memorandum

to Hugh Davis, Marin County Flood Control and Water Conservation District

from Karen Lancelle, ESA

subject San Anselmo Flood Risk Reduction Project Mitigation Planting Addendum – Response to Public Comments

CREEK PLAZA
SLOPES/LANDSCAPE
ARCHITECT FOR
REIMAGINE PARK

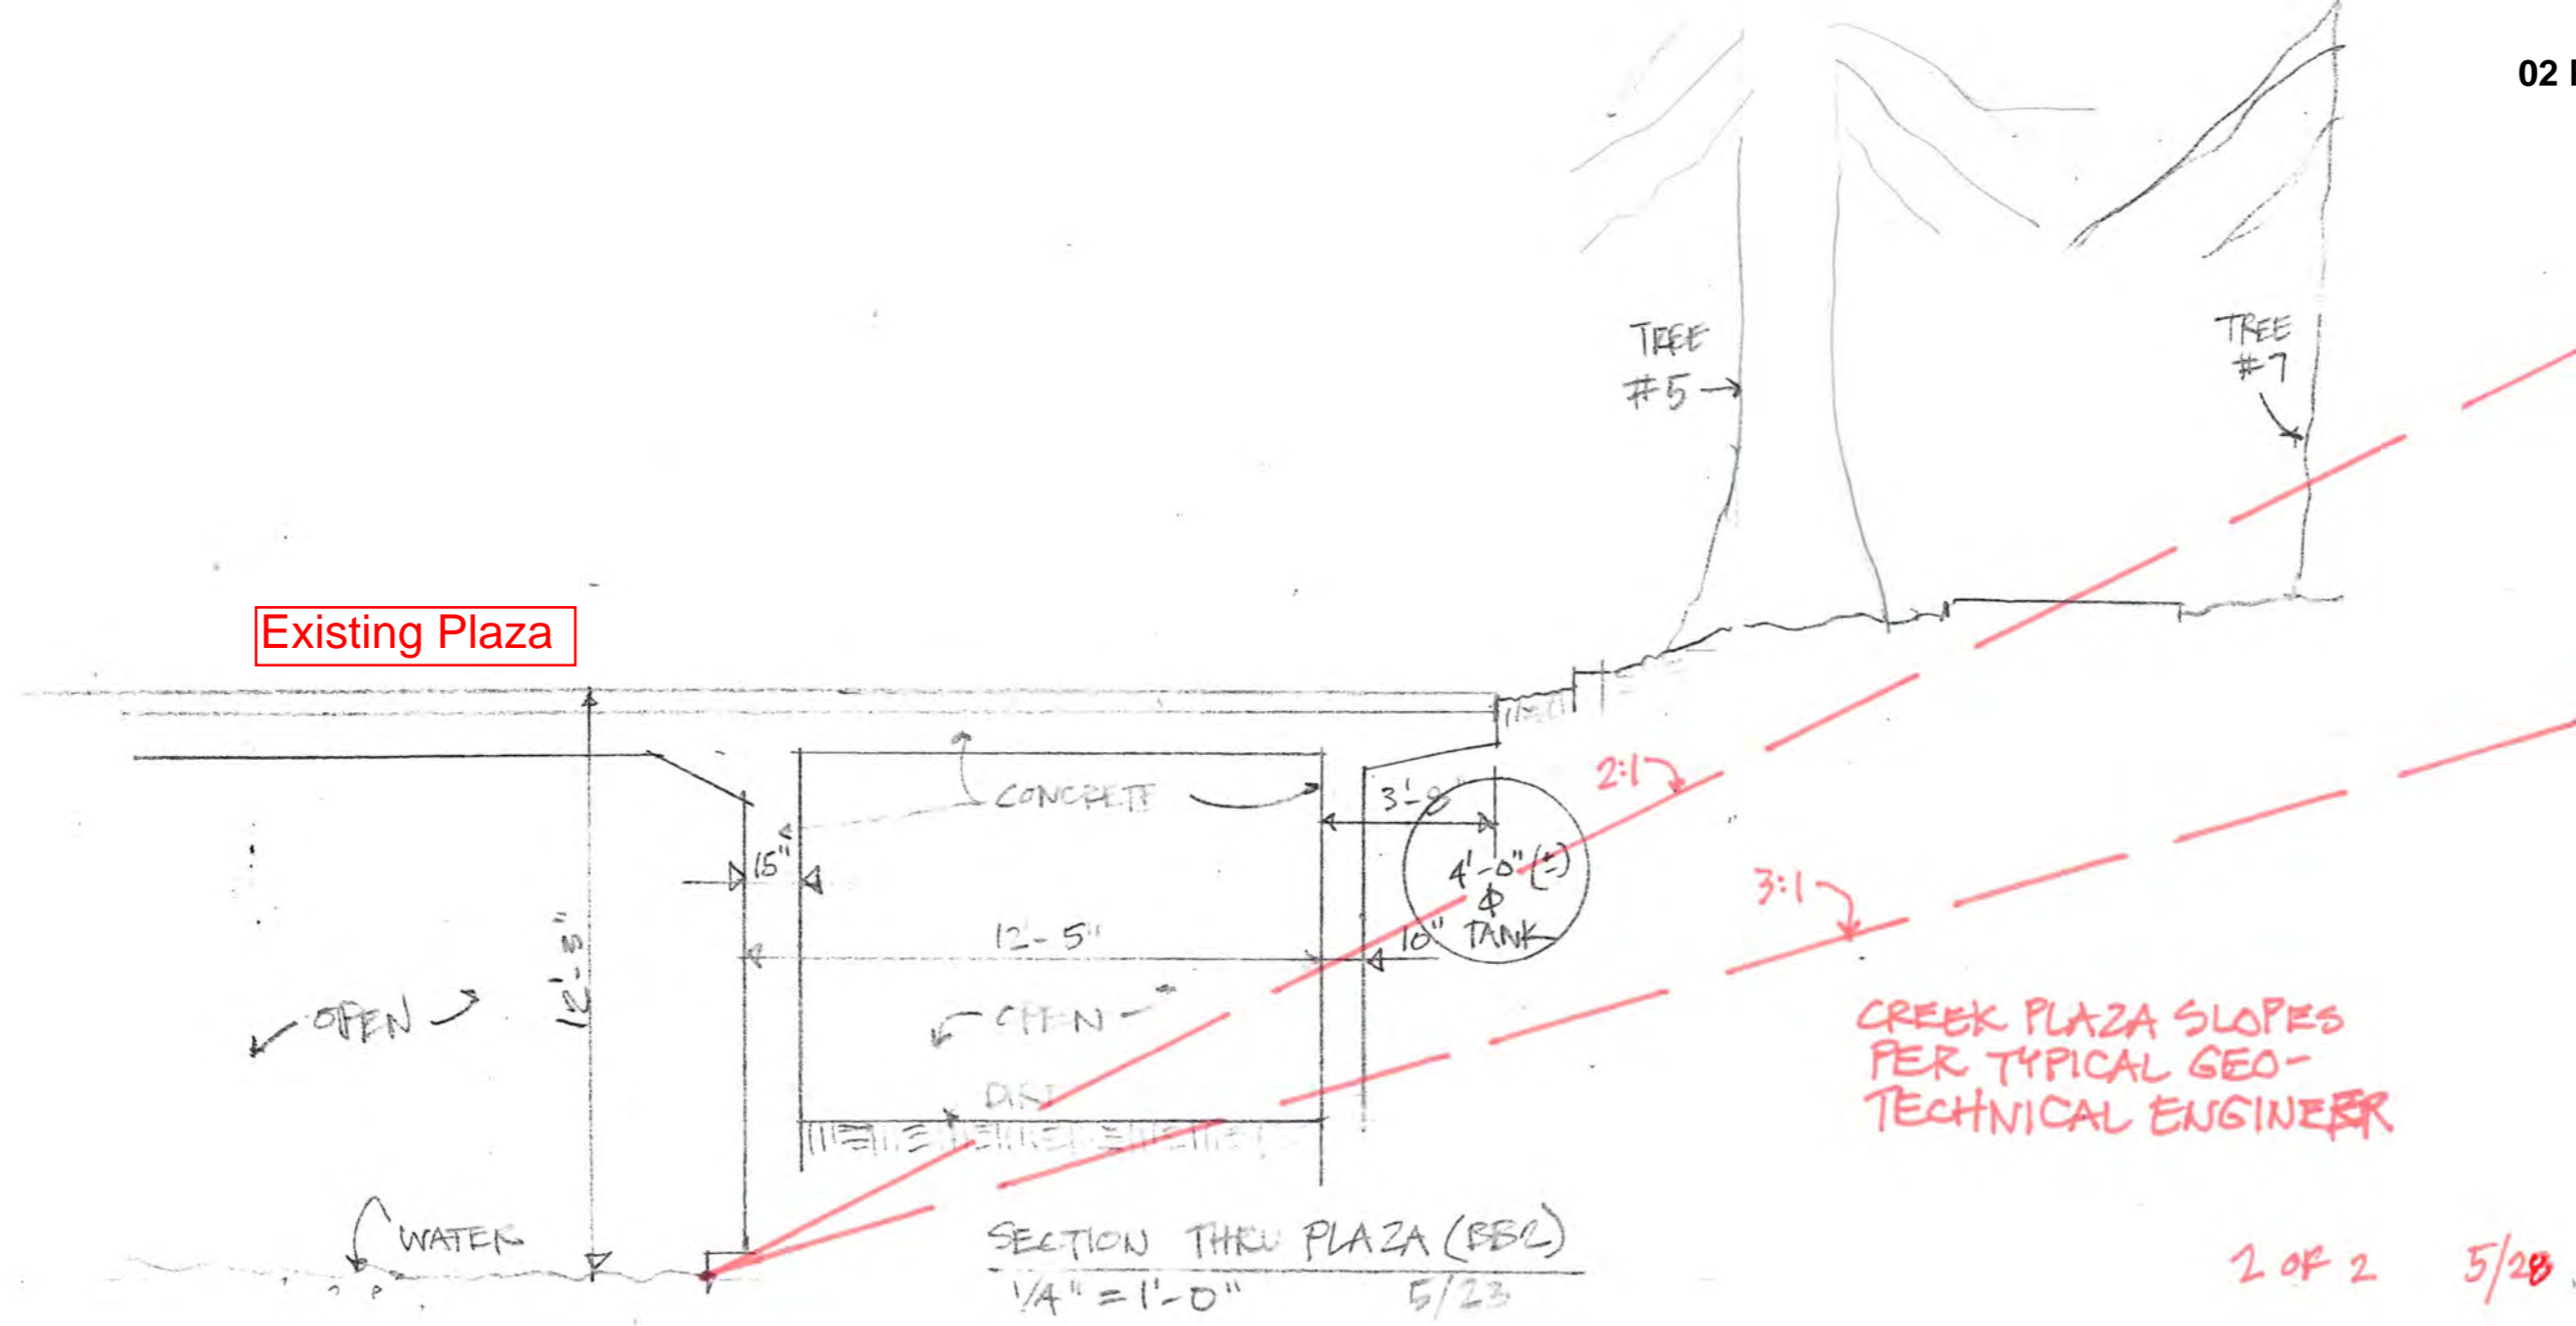
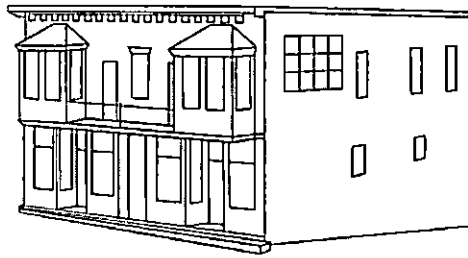
CREEK FILL
(NEVER ALLOWED
BY ARMY CORP.
OF ENGINEERS!)

Cross section of slope from bottom of existing concrete plaza structure. The red lines show the slope not being constructed in the flow of the creek.
